C. Y. GEOTECH, INC.

July 27, 2007

P.N. CYG-06-4508

Subject: Review of Drainage Plans and Infiltration Pit Plan, Proposed Five Unit Condominium, Lot S, Block 136, Santa Monica Tract, 1327 Euclid Street, Santa Monica, California

Figure 1

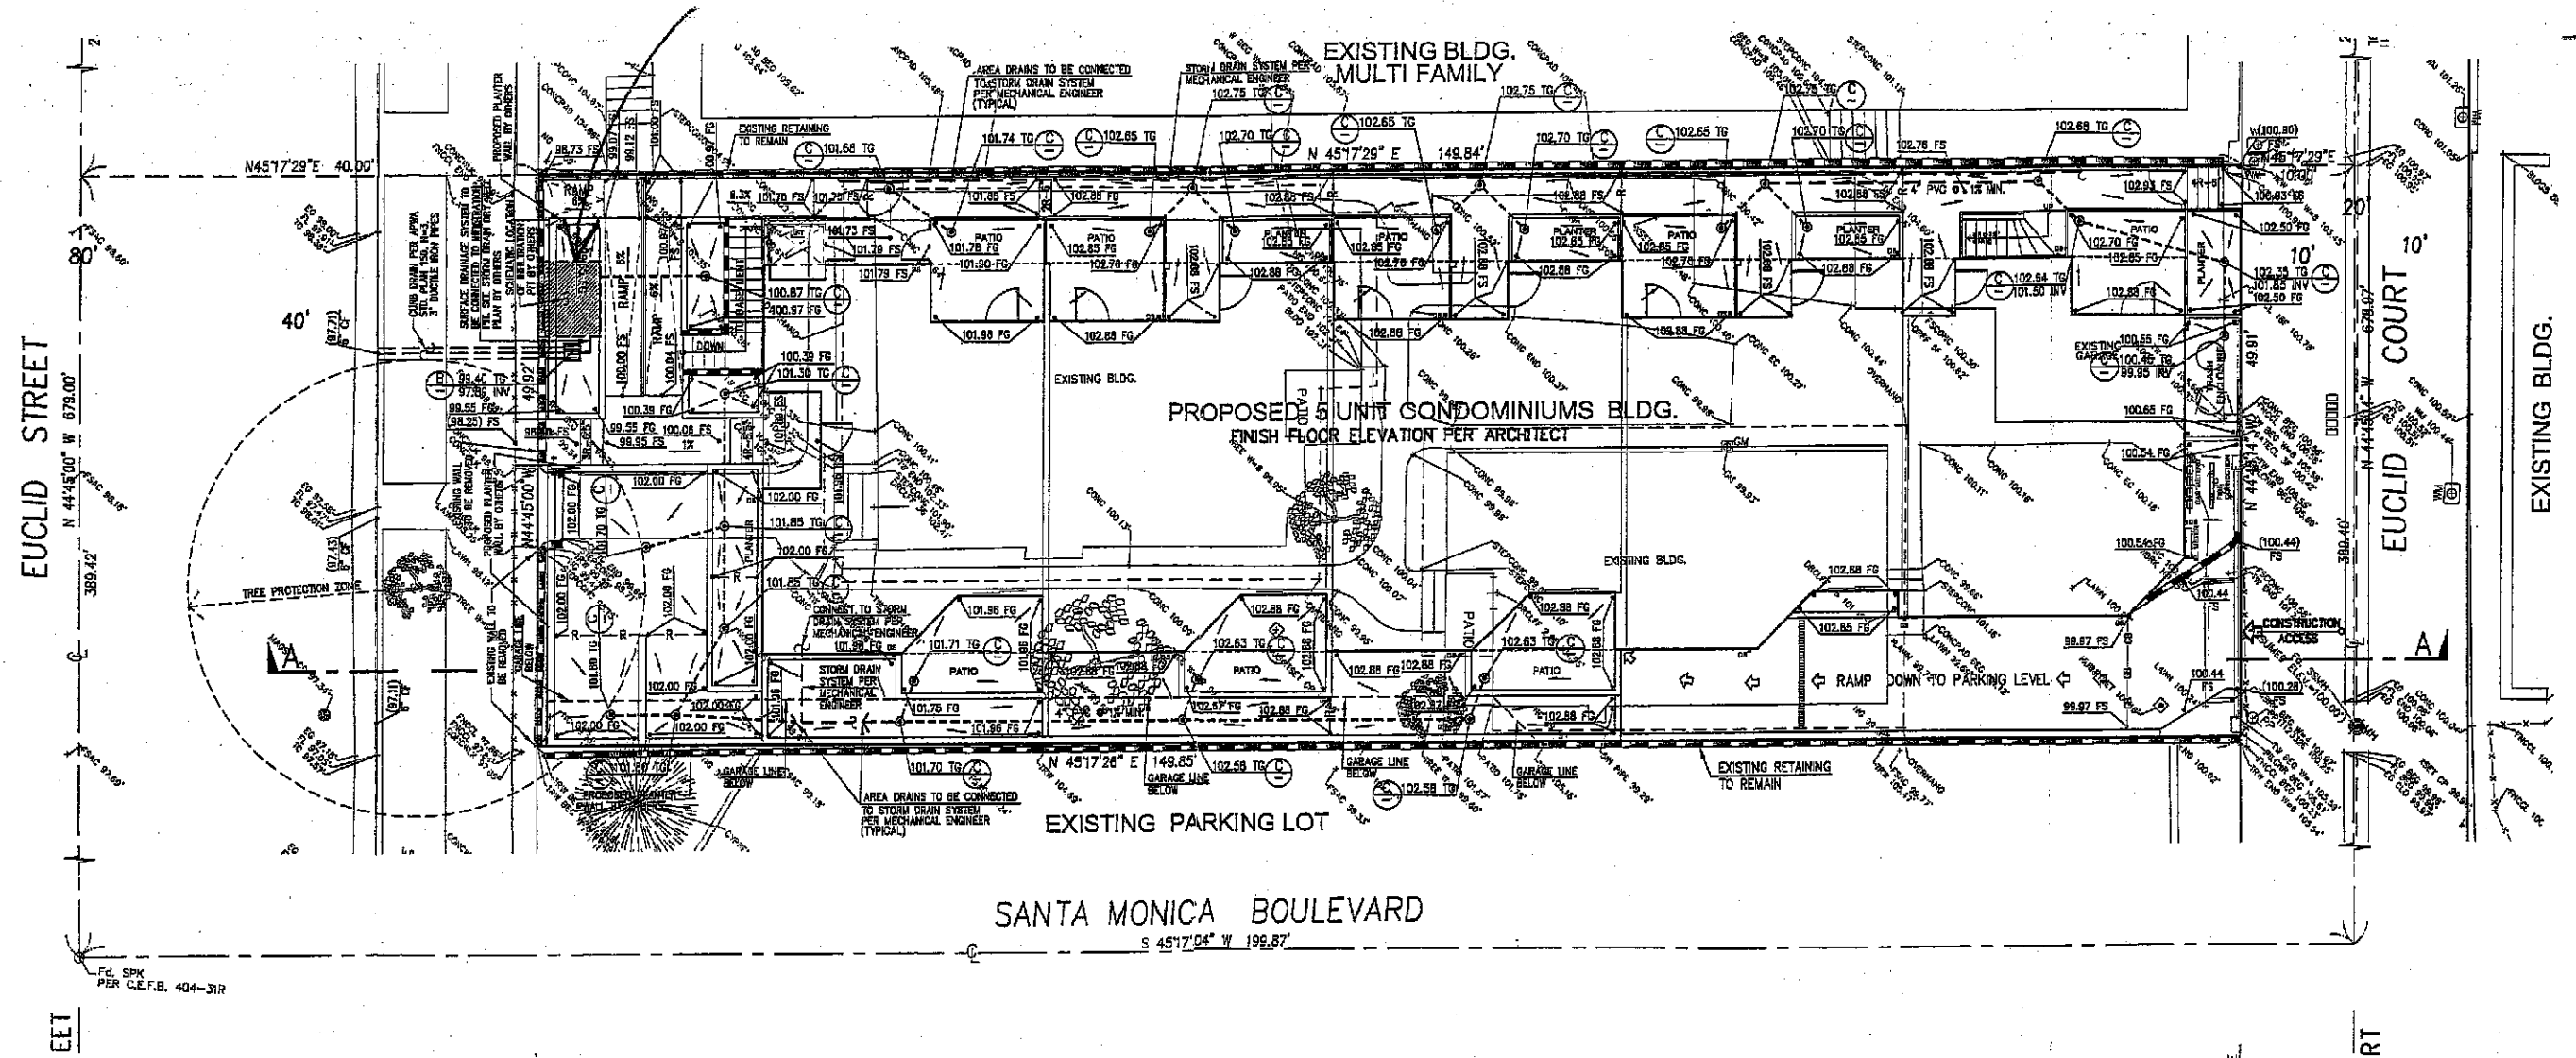
The location of the proposed infiltration pit is shown on Figure 1. The illustration of the proposed infiltration pit is shown on Figure 2. As shown on Figure 2, the infiltration pit will be 11 feet long, 7 feet wide and 5.5 feet deep. Based on the information provided by GM Engineering, the infiltration pit should have a minimum capacity of 423 cubic feet.

One (1) test trench was to depth of approximately 4 feet in the area of the proposed infiltration pit (see Figure 1). Older alluvium was encountered in the test trench. The older alluvium consisted of brown clayey sandy silt and brown gravelly clayey silty sand in a moist to very moist and moderately dense to dense condition.

Figure 2

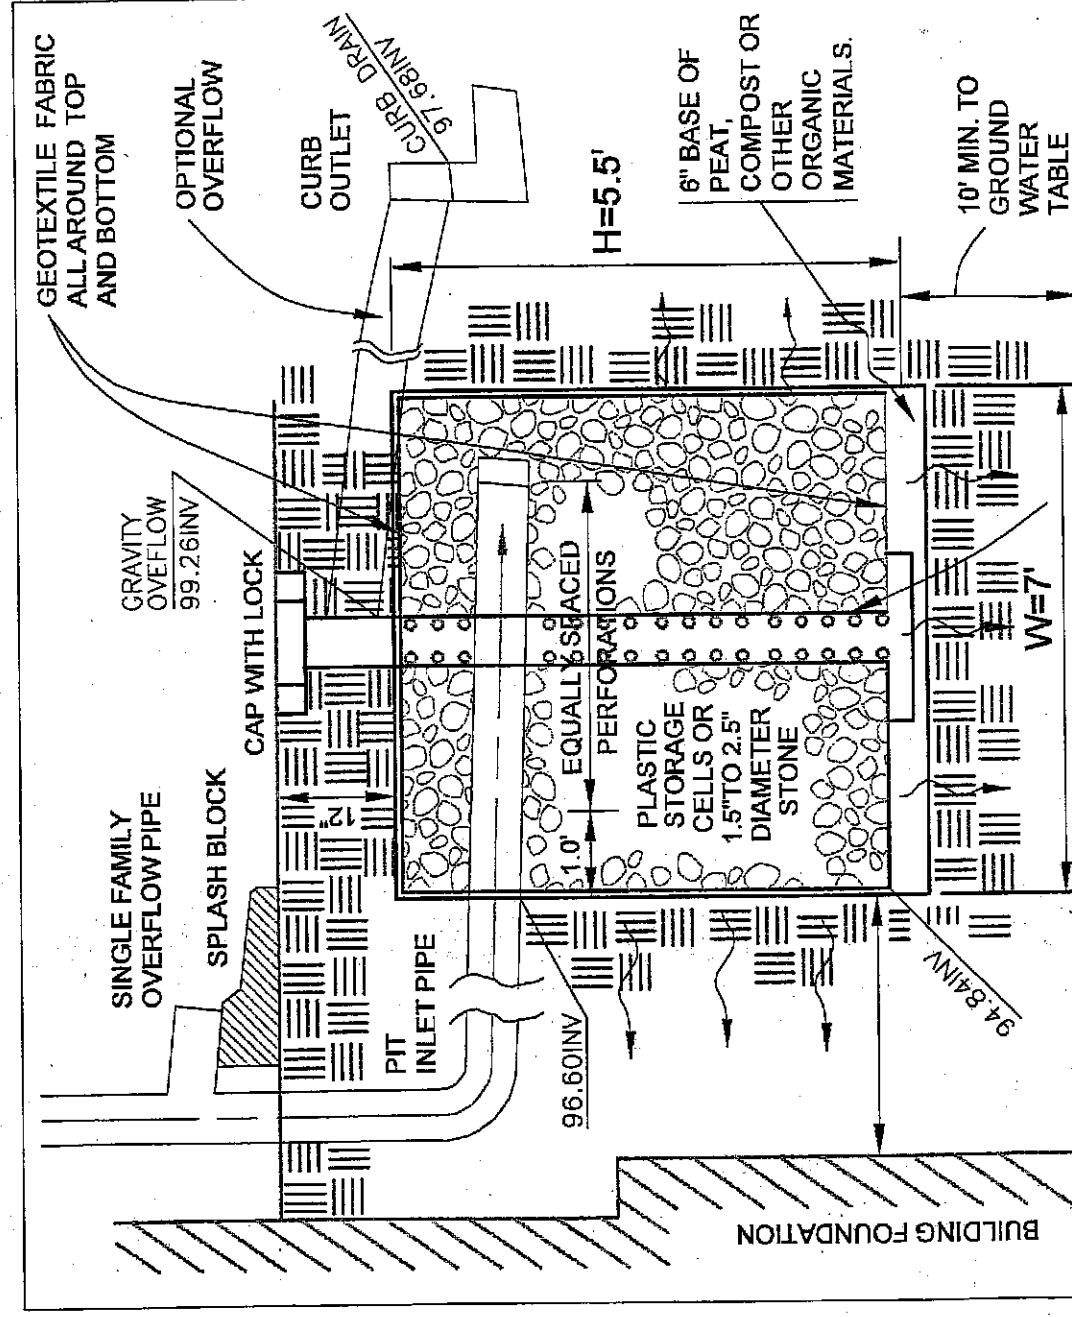
1. Onsite soil in the infiltration pit area can be used for the percolation of run-off water.
2. The proposed infiltration pit has adequate capacity for the mitigation of surface run-off as determined by GM Engineering.
3. The proposed infiltration pit will not undermine the foundation soil and cause adverse effects on the stability of the proposed building structure and adjacent structures.

It is our opinion that the proposed infiltration pit is acceptable from a geologic and geotechnical engineering viewpoint. Water overflowing from the infiltration pit should be diverted away from the building foundation.
